Marge Schmuckal - Re: 34 Howard St.

Proposed Renovation @ 34 Howard St.
Portland, ME
August 27, 2014

PROPOSED PLANS
A4

Marge Schmuckal - Re: 34 Howard Street - 2014-01970 - 014-E-019

gabled roof.
Proposed Revisions @ 34 Howard
Sept. 9, 2014

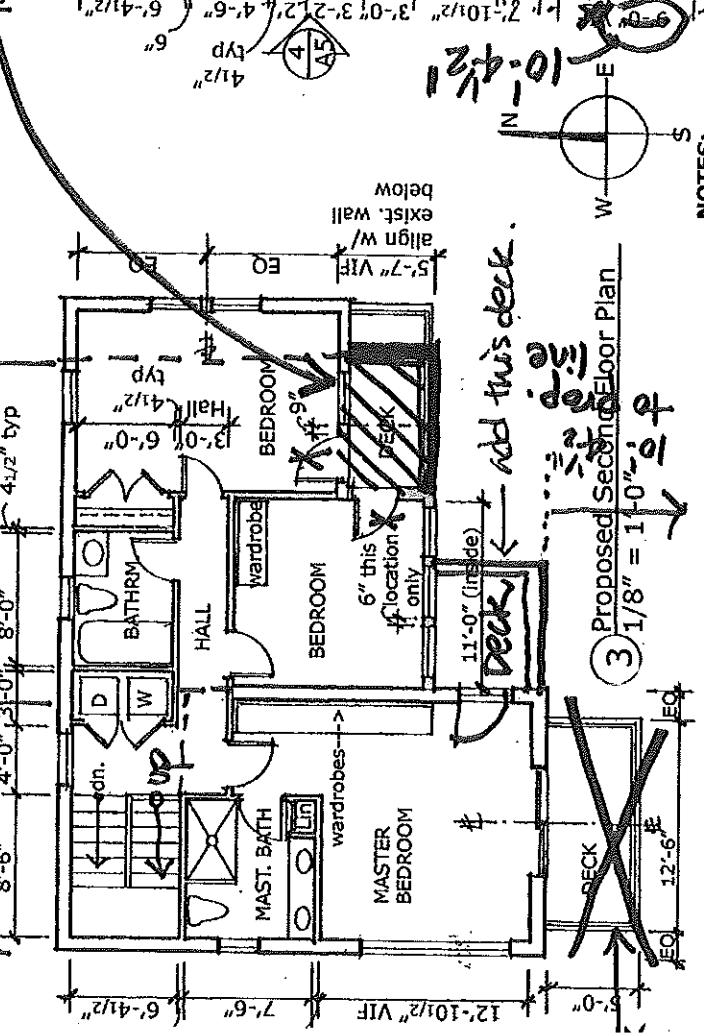
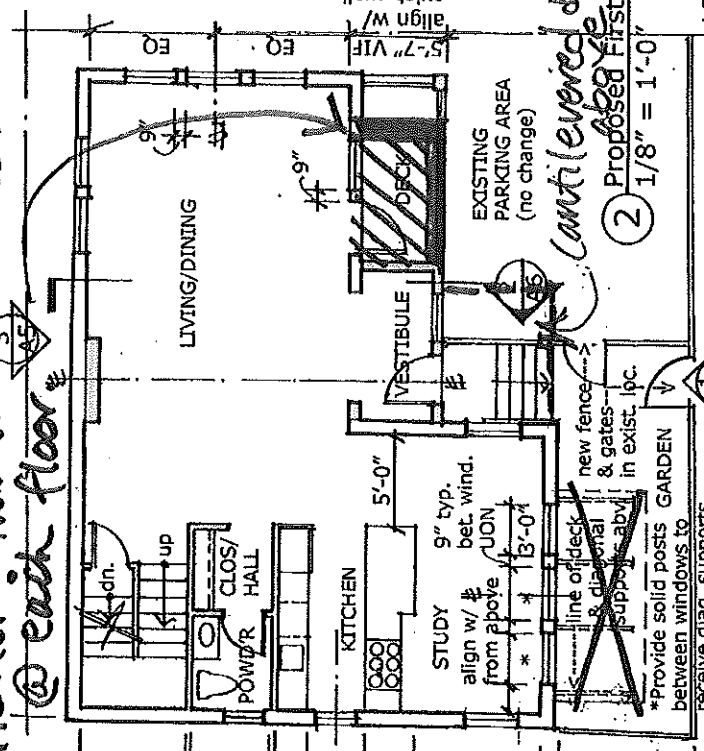
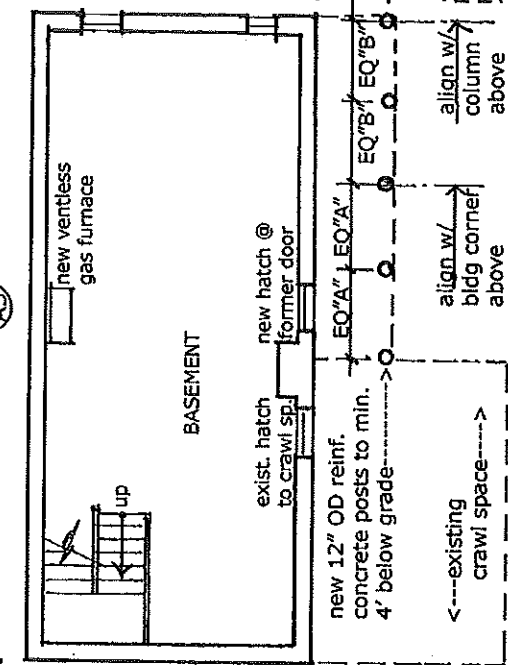
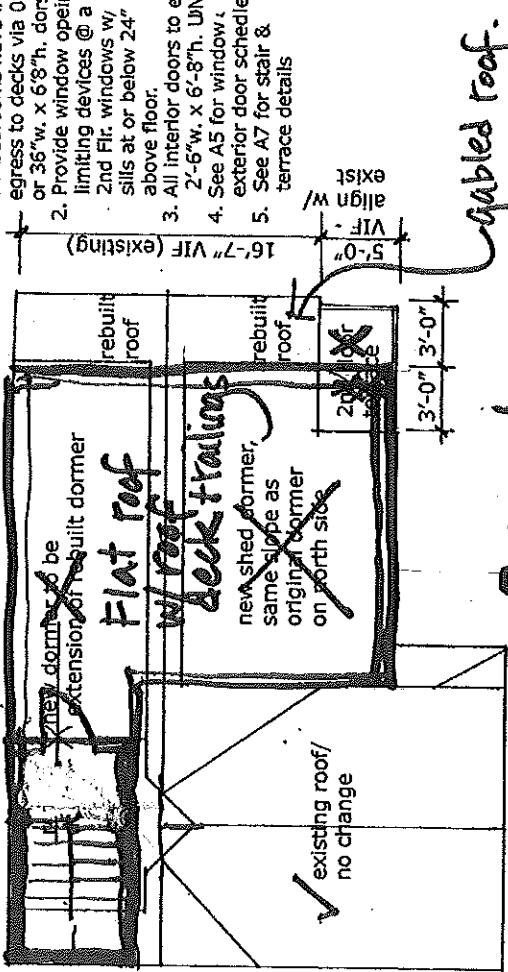
Marge, I've attached a marked-up A4/Proposed Plan drawing to try to communicate what the Owner would like to do at this point, following the results of our meeting yesterday. The notes on the drawing indicate the following:

1. Remove "cantilevered" deck from second floor off of south side of Master Bedroom, because of encroachment on setback. (The building appears to be 10' - 4-1/2" off the property line.)
2. Add cantilevered second floor deck above the outside entry way, off of the east side of the Master Bedroom as shown.
3. Bring stair bulkhead up to roof, and create flat roof above the areas formerly noted as shed dormers. This would have 42" high railings, of course. There would still be a gabled end of the building facing Howard St. - in-other-words, we'd have a gabled area about 3' deep at the end of that section of the building and the flat roof/roof deck would be behind it.

The only other issue is this: in lieu of what we showed as proposed small decks on the 1st and 2nd floors off of the living room and the east bedroom, would it be possible to include this space as interior space instead of decks? This would add about 40 feet to each floor, with the total net added square footage from the original to be approx. 158 SF (i.e. 78 SF previously shown + 80 SF). This is shown on the drawing as hatched area.

Can we absorb this area into interior? This work add 40 SF ± @ each floor

What you marked up looks like it could work. I would need a little more info on how the stairs to the roof would be constructed along with a good elevation.
